HONOR CHARTER SCHOOL

HONOR CHARTER SCHOOL BUILDING CORPORATION
8250 Bent Grass Meadows Drive, Peyton, Colorado 80831
Owner Project No. 3225193
AGENCY NUMBER: AHCA-123456.78

ELECTRICAL
SITE PLAN

V1_Lighting Plan.pdf Markup Summary

LDN6 500-3000 Lumens

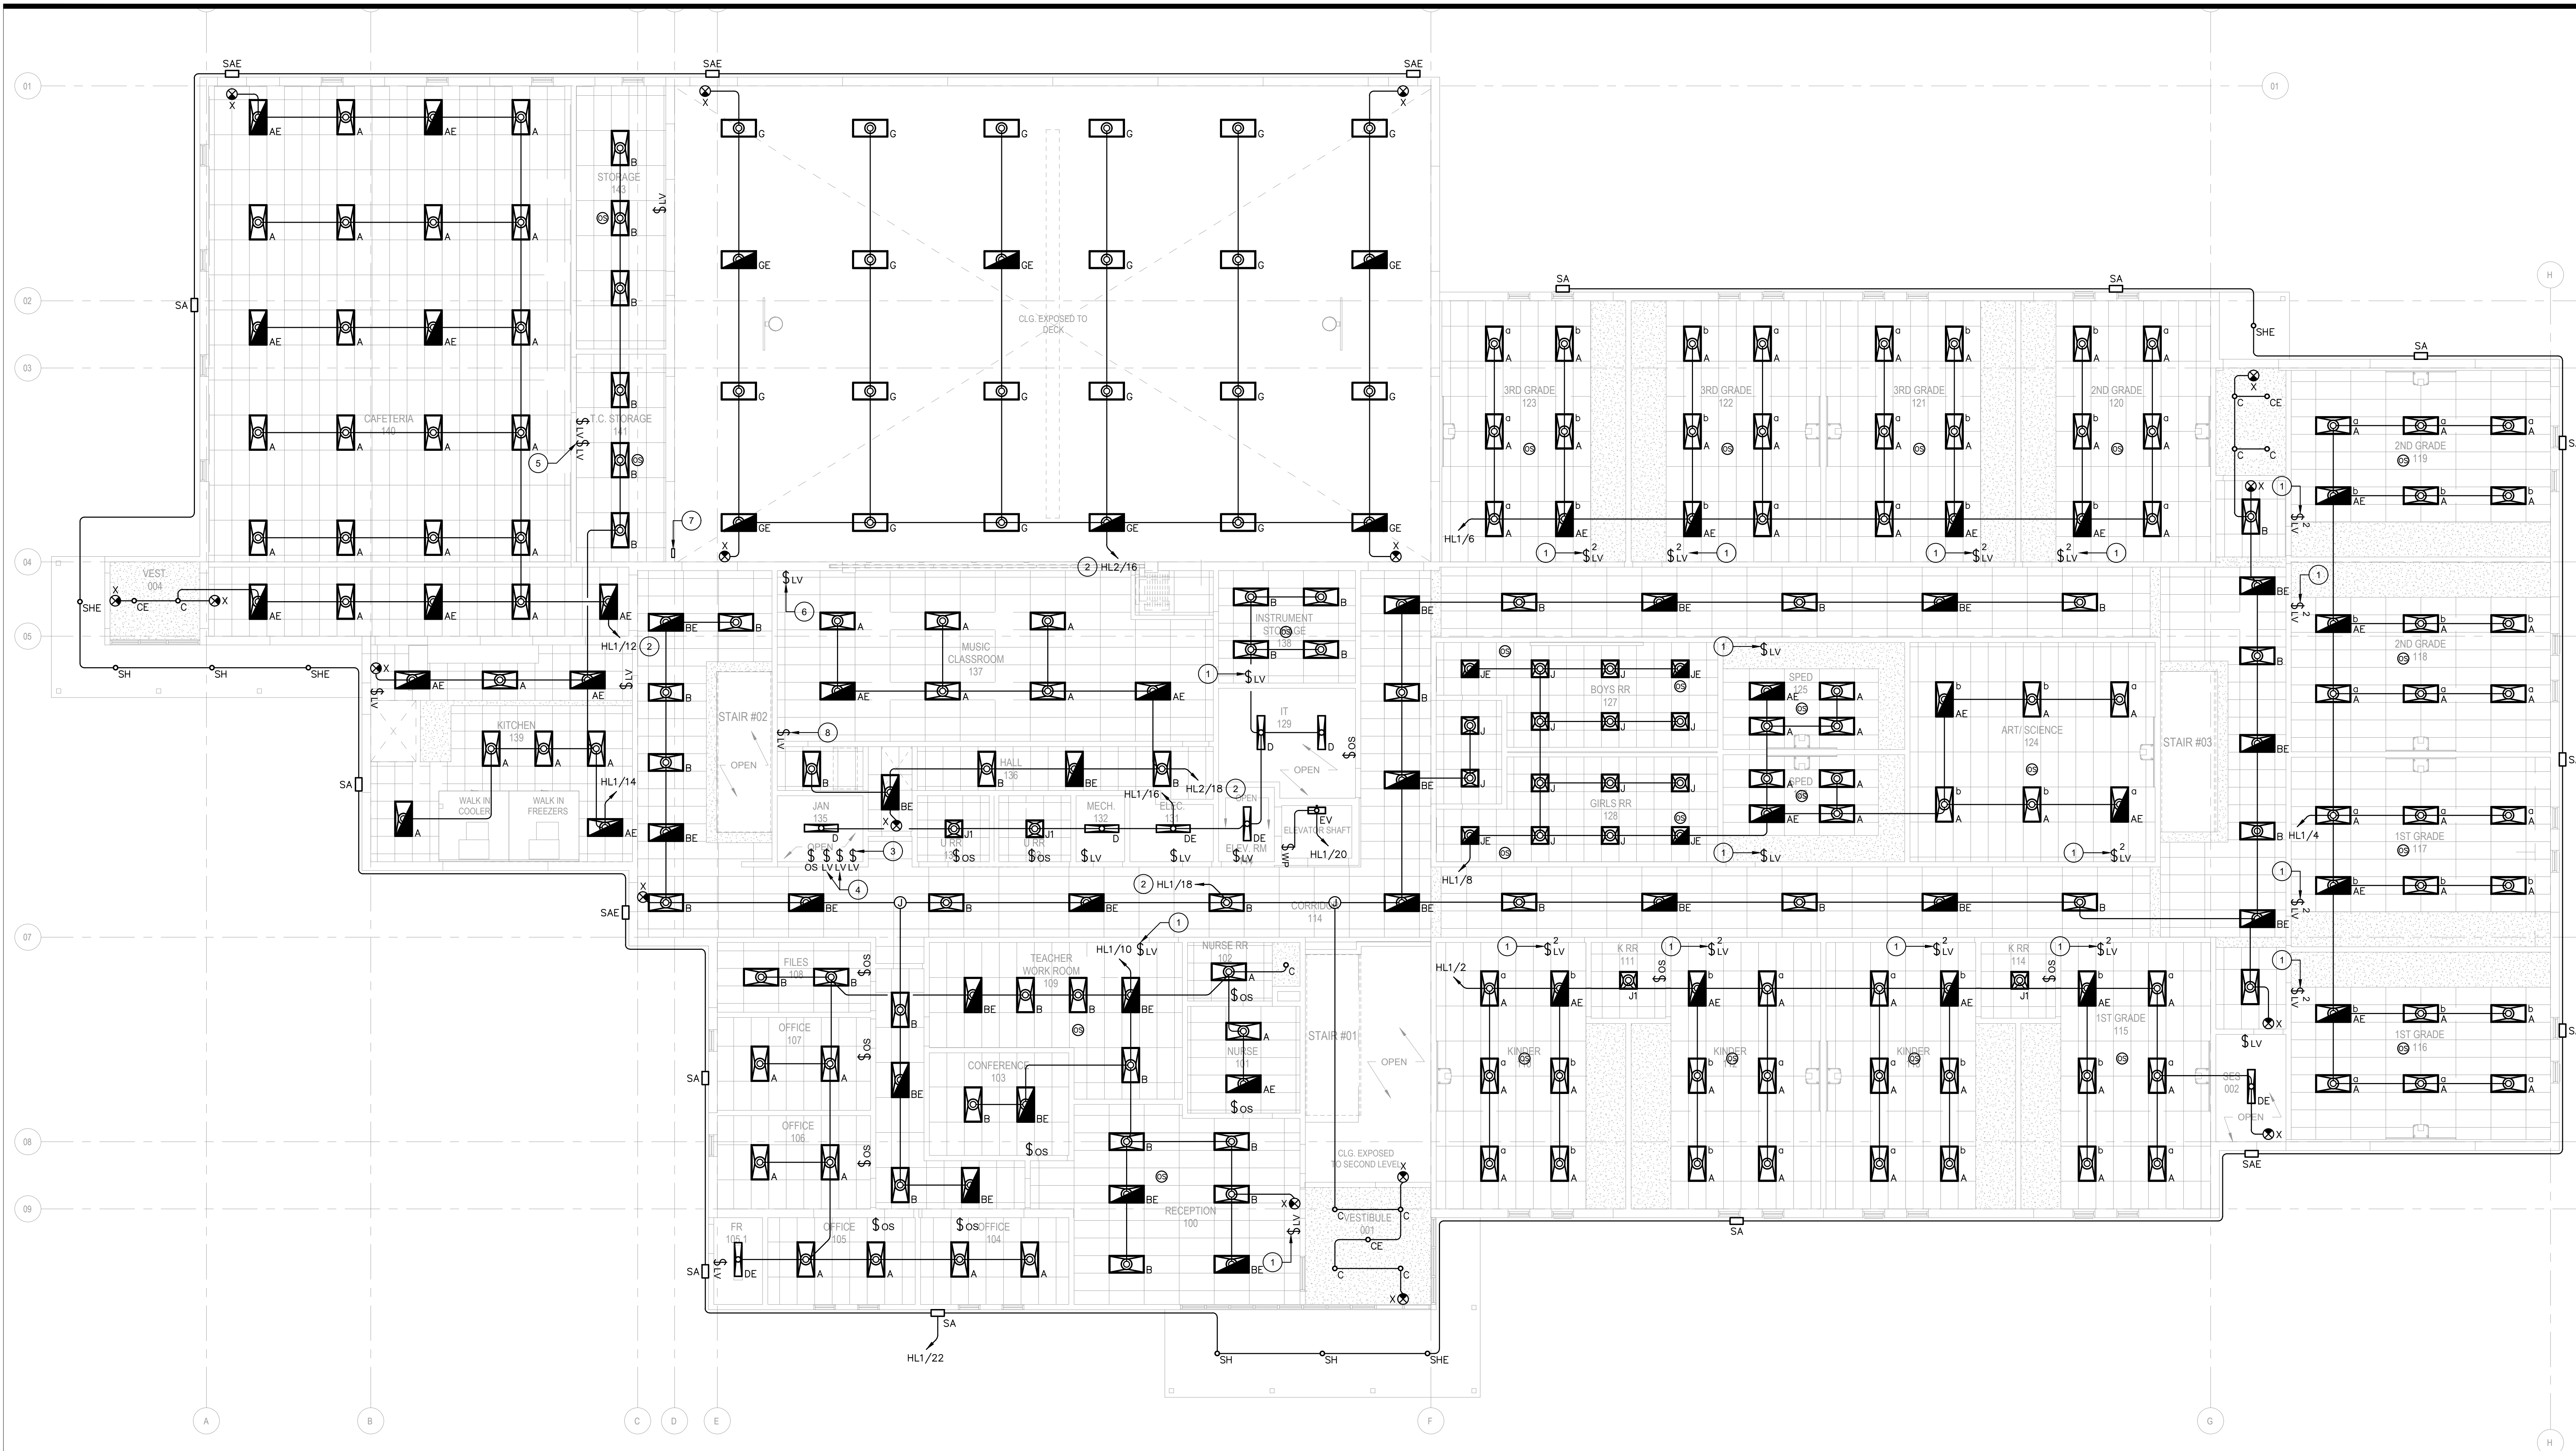
Is this what you are proposing to reduce impacts to residents?

3 & 4. "HOUSE SIDE SHEILDS" HAVE BEEN SPECIFIED AT LIGHT POLES TO REDUCE POTENTIAL GLARE INTO RESIDENTIAL AREAS/ REF SHEET ES-113 FOR CUT SHEETS.

"HOUSE SIDE SHEILDS" HAVE BEEN SPECIFIED AT LIGHT POLES TO REDUCE POTENTIAL GLARE INTO RESIDENTIAL AREAS/ REF SHEET ES-113 FOR CUT SHEETS.

LED LAMPS HAVE BEEN PROVIDED. REF SHEET ES-113.

'SC'/'SD'/'SF' FIXTURE POLE MOUNTING DETAIL
N.T.S.

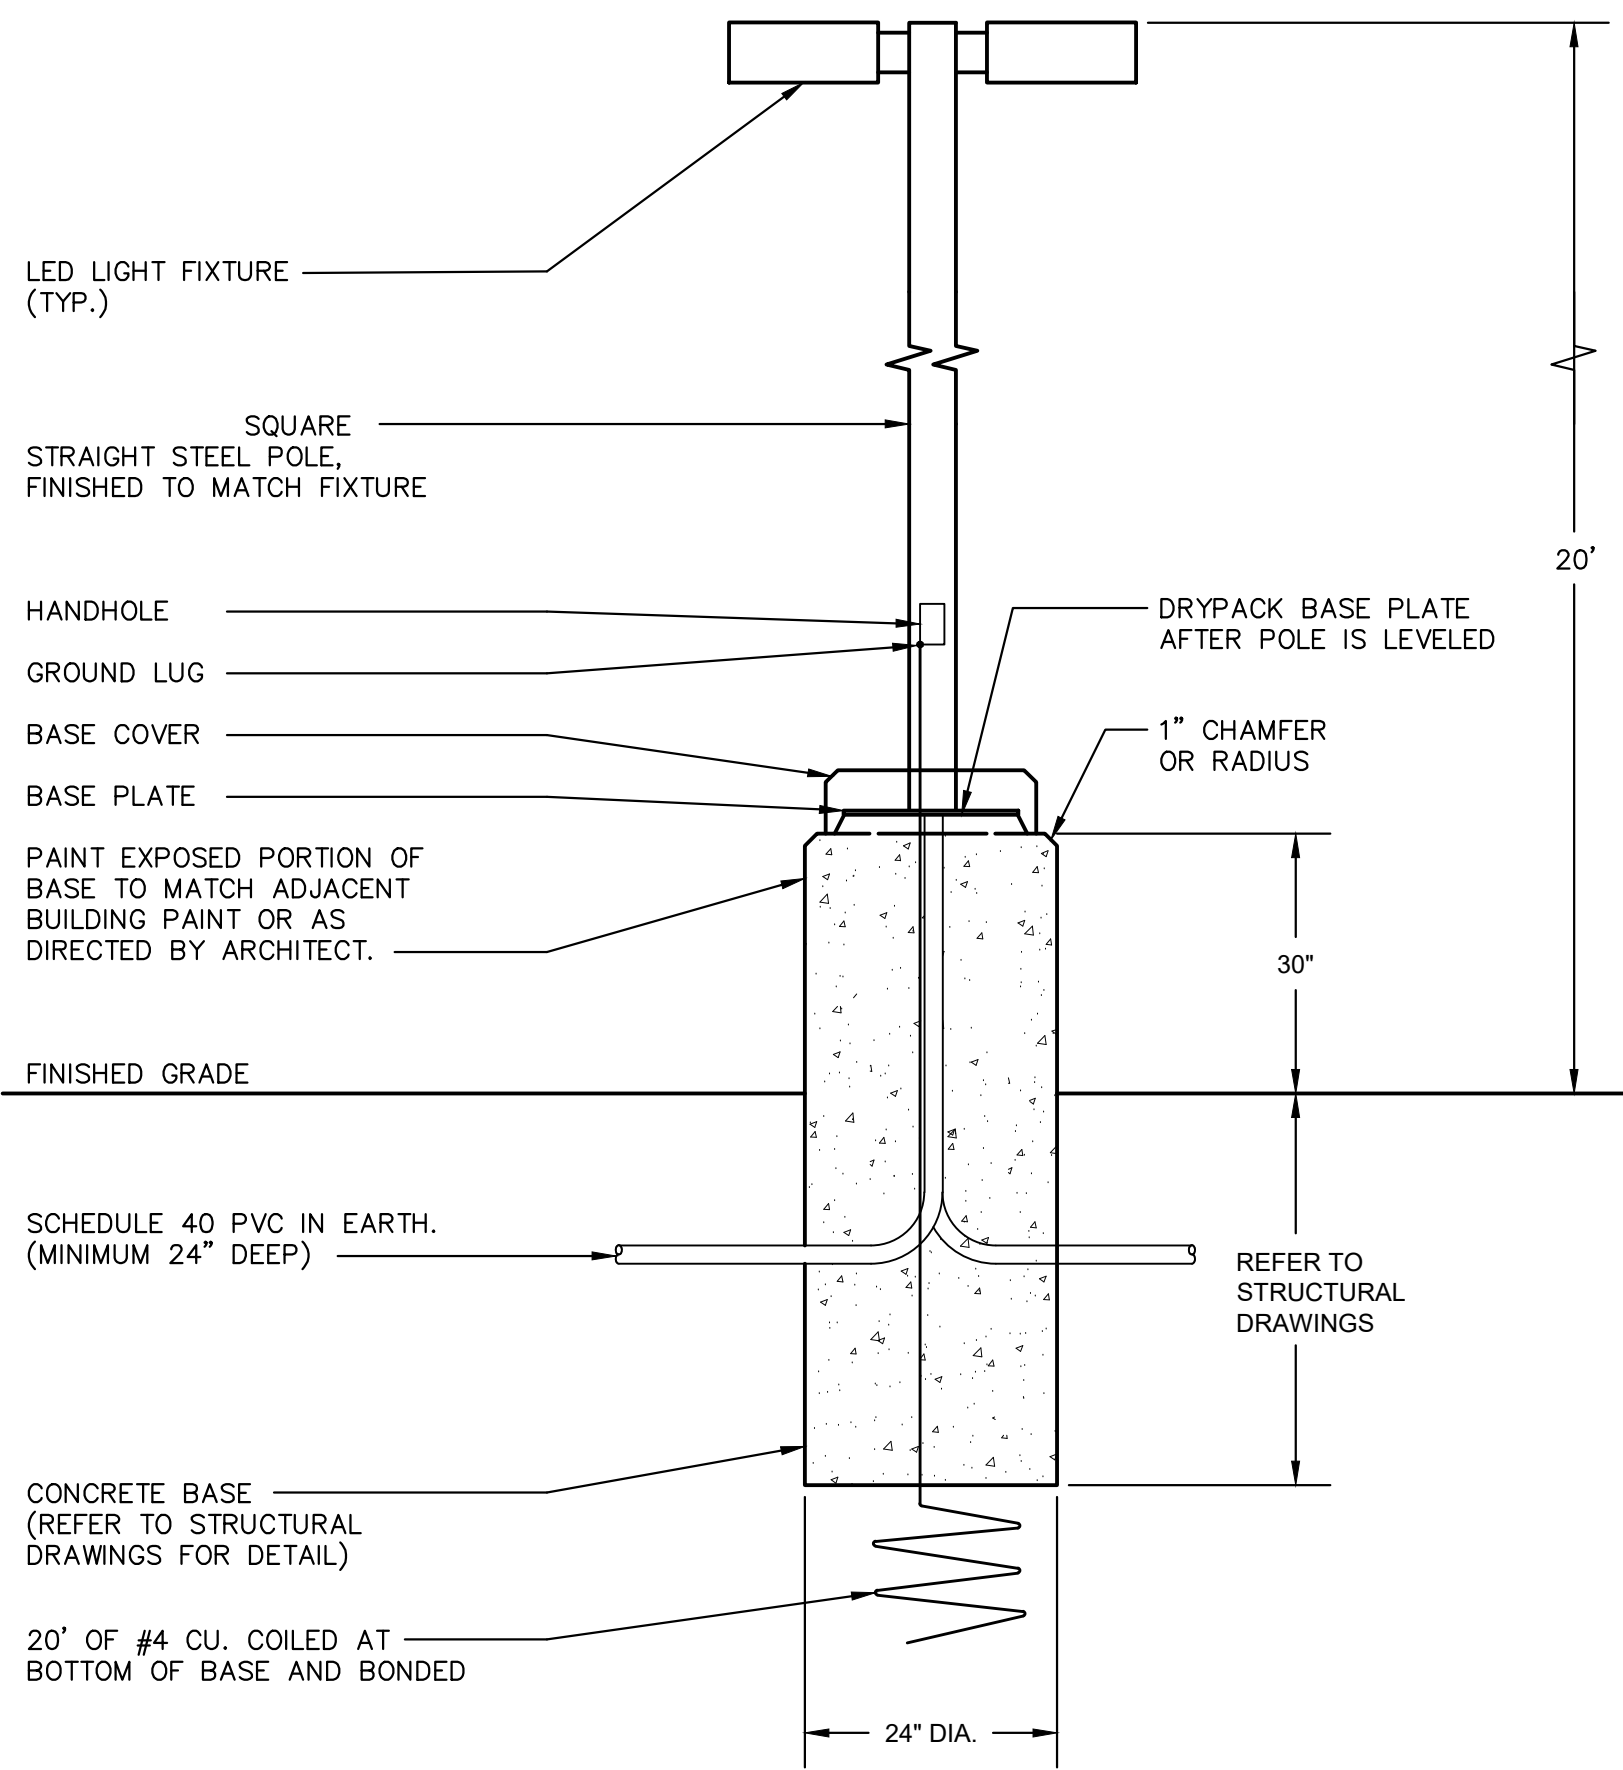
Add property lines and verify full cut off fixtures and provide height of pole mounts. Please see lighting standards in Code

LIGHT POLES ARE DESIGNED TO THE ABOVE STANDARD/ REF SHEET E-802 FOR DETAIL. THERE ARE NO LIT BOLLARDS OR ILLUMINATED LANDSCAPING SPECIFIED ON THIS PROJECT.

CONFIRMED/ REFER TO SHEET E-802 FOR PARKING LOT LIGHTING DETAILS.
